HISTORIC AND DESIGN REVIEW COMMISSION

HDRC CASE NO: 2019-004
ADDRESS: 2310 ROOSEVELT AVE
LEGAL DESCRIPTION: NCB 7456 BLK LOT 11 (D FAULKNER)
ZONING: I-1, H, RIO-5
CITY COUNCIL DIST.: 3
DISTRICT: Mission Historic District
APPLICANT: Dathan Faulkner/Allstate Gear
OWNER: Dathan Faulkner/Allstate Gear
TYPE OF WORK: Construction of a storage structure
APPLICATION RECEIVED: January 02, 2019
60-DAY REVIEW: March 03, 2019
REQUEST:

The applicant is requesting a Certificate of Appropriateness for approval to construct a storage structure at the rear of the site to feature a footprint of approximately 12,000 square feet.

CIVIL SITE PLAN
BUILDING PERMIT EXHIBIT

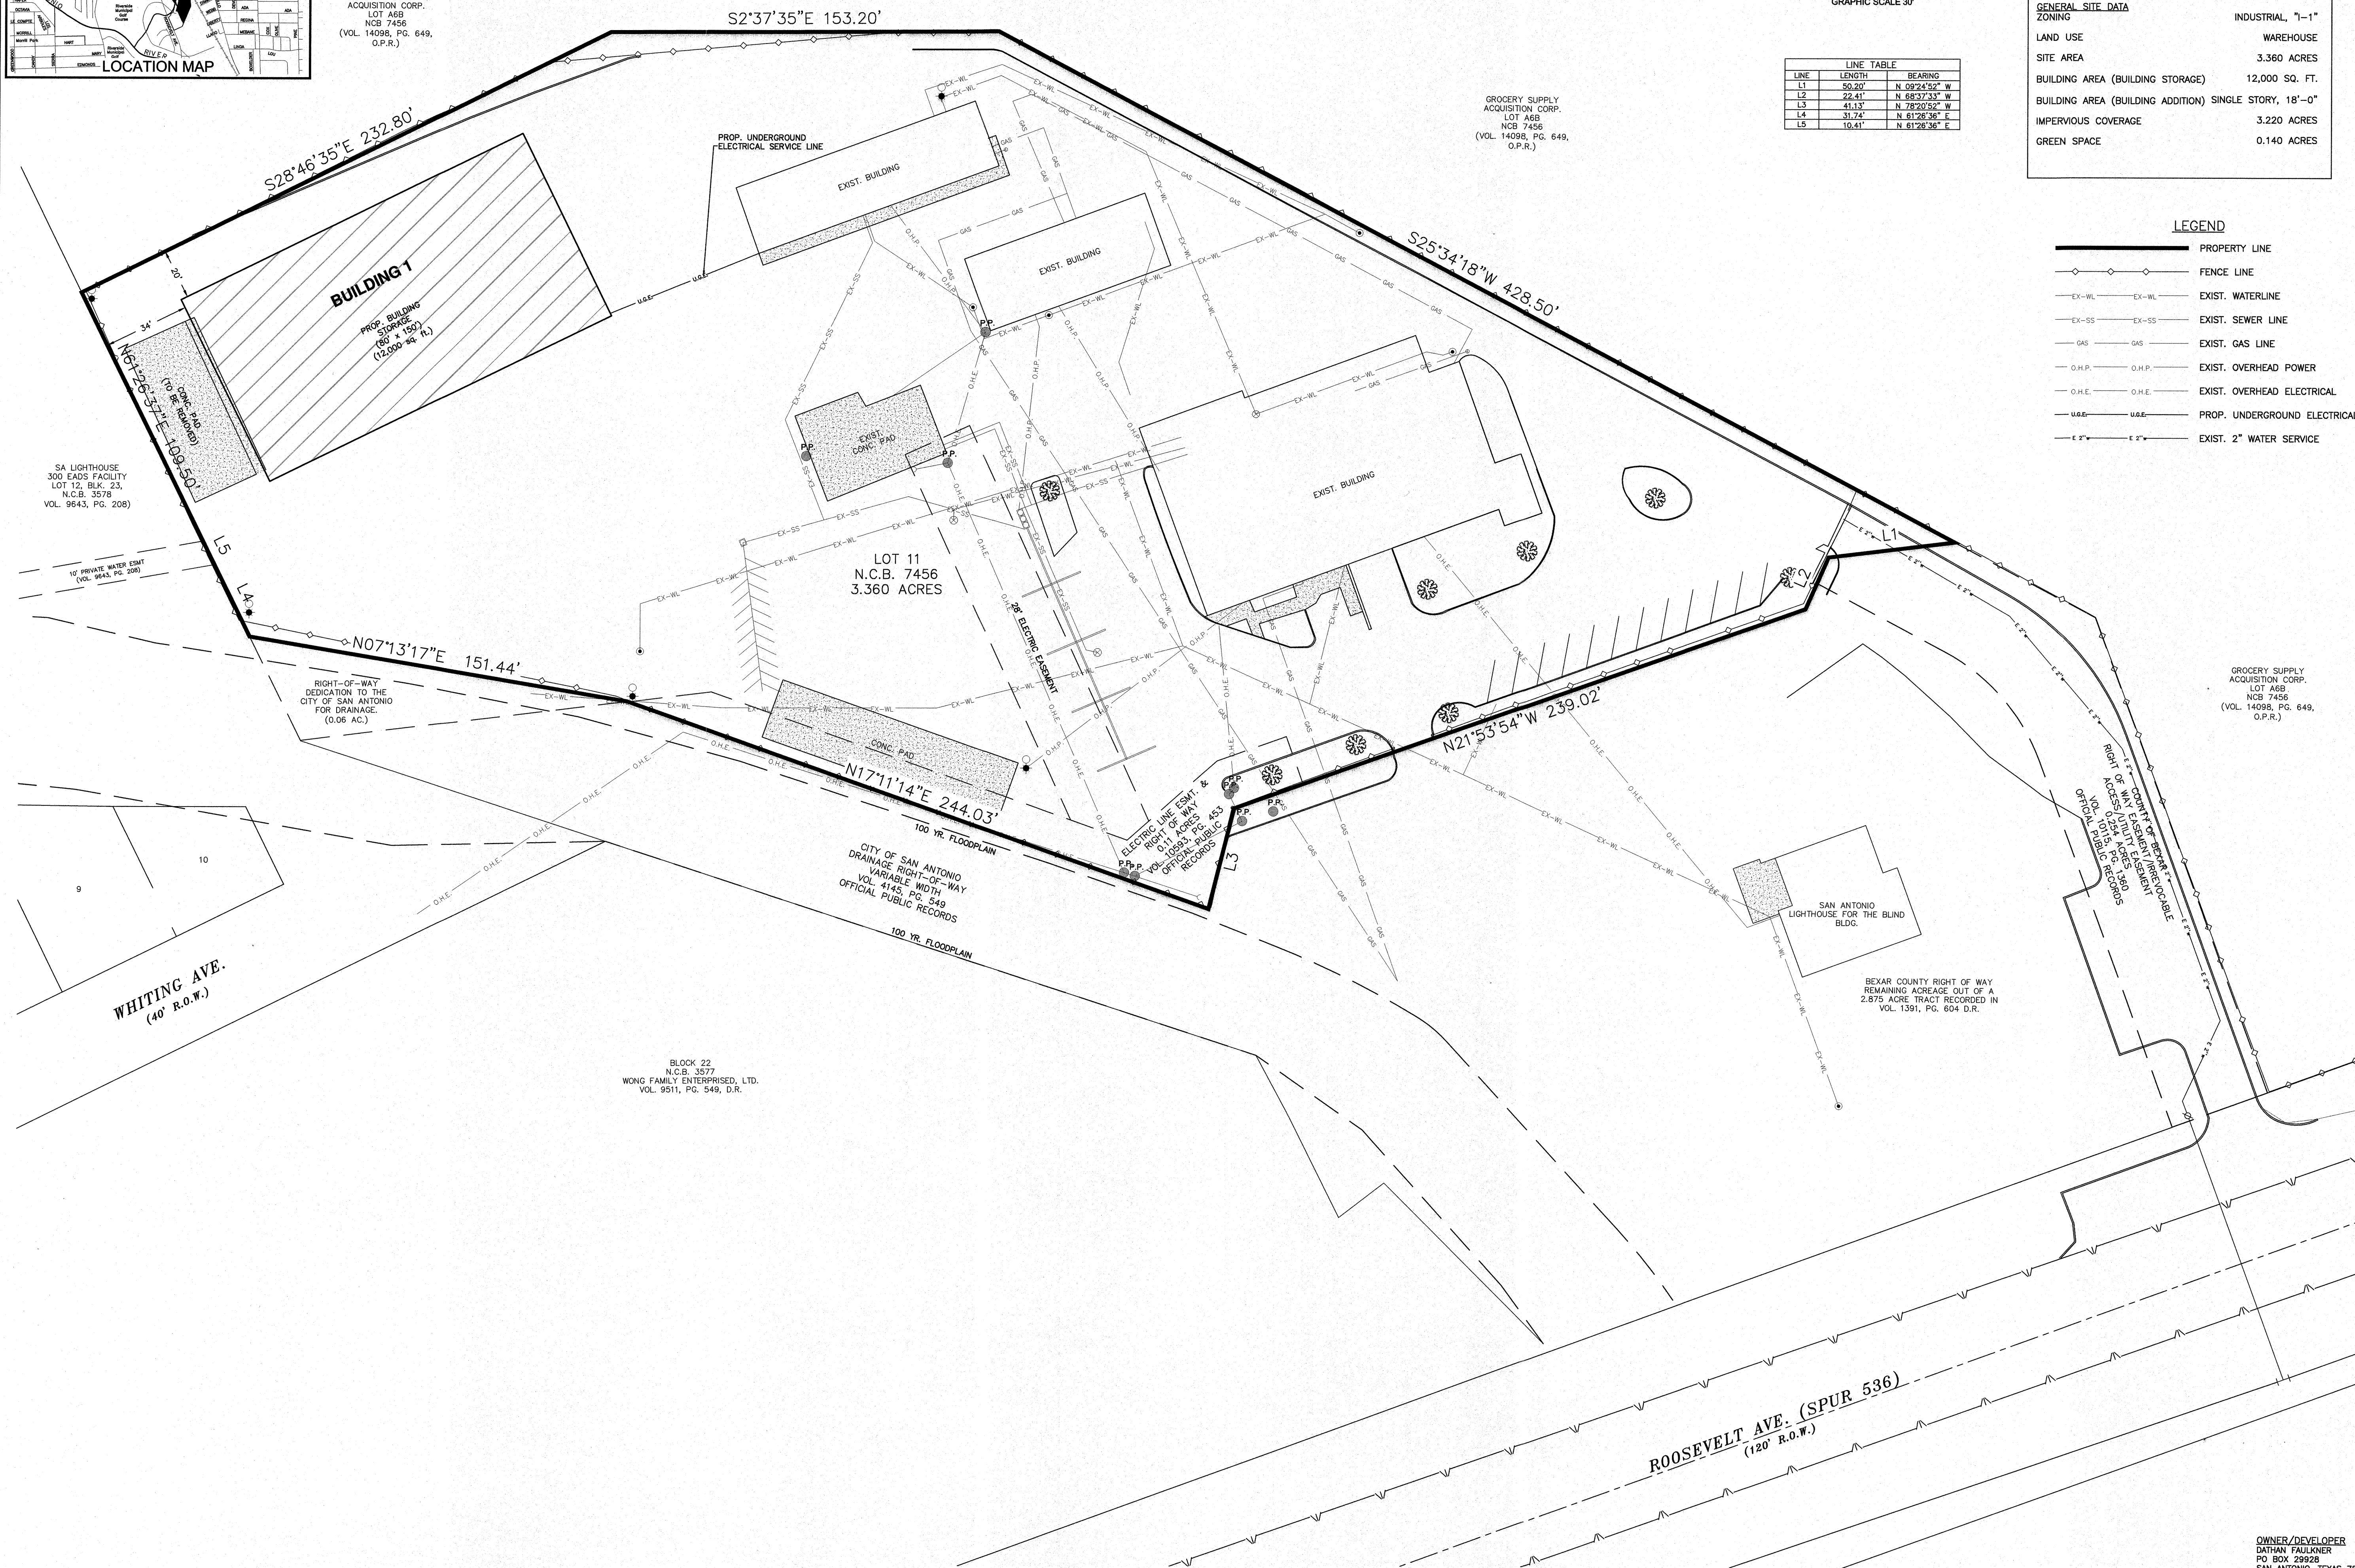
- b. BUILDING SPACING – Per the Mission Design Manual, Buildings should be arranged to include interstitial spaces between structures that maintain a comfortable pedestrian scale. Per the applicant's site plan, the applicant has arranged the proposed new structure to feature spacing from existing structures that is consistent with the Manual.

- c. SETBACKS – In general, new buildings should follow the established pattern of the block in terms of front building setback where there is a strong historic context (adjacent contributing buildings). On corridors where building setbacks vary or are not well-defined by existing contributing buildings, buildings should maintain a minimum front setback of 15' for properties north of SE Military and a maximum front setback of 35' for properties south of SE Military. The applicant has proposed to site the storage structure at the rear of the site, where visibility from the right of way at Roosevelt is minimal. Staff finds the proposed setback appropriate.
